**SERVICE BULLETIN****Inspection and/or installation of lock washer A6 for  
ROTAX® Engine Type 915 i A (Series) and 912 i (Series)**

ATA System: 24-20-00 Ignition housing

Inspection for and/or installation of lock washer A6 for ROTAX® Engine Type 915 i A (Series) and 912 i (Series).

Fig. 1

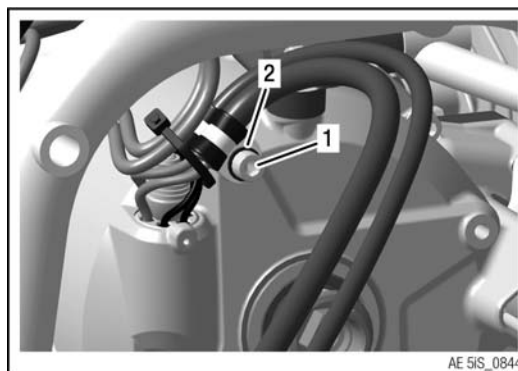
| Step | Procedure  |
|------|--|
| 1    | Check Allen screw M6x20 (1) at the generator wiring clamps for the presence of lock washer A6 (2). |
| 2    | If a lock washer A6 is found installed, proceed to 3.5.3).   |
| 3    | If no lock washer A6 is present, proceed to section 3.5.2).  |

Fig. 2

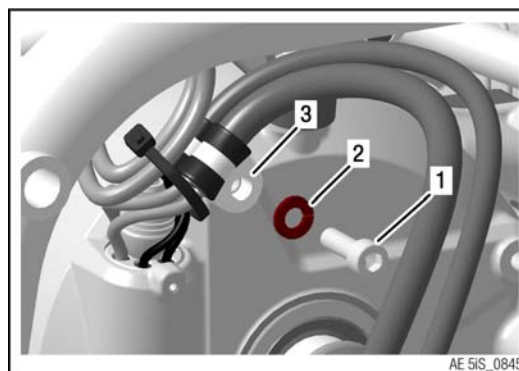
| Step | Procedure  |
|------|--|
| 1    | Remove Allen screw M6x20 (1).  |
| 2    | Reinstall Allen screw M6x20 with a new lock washer A6 (2) part no. 945831.<br>Reinstall 2 cable clamps 8/M6 (3). |

NOTE: The bends of the cable clamps must be installed in diametrically opposed manner (back to back).

| Step | Procedure  |
|------|--|
| 3    | Adjust cables. Tighten Allen screw M6x20 (1). Tightening torque 10 Nm (89 in. lb). |
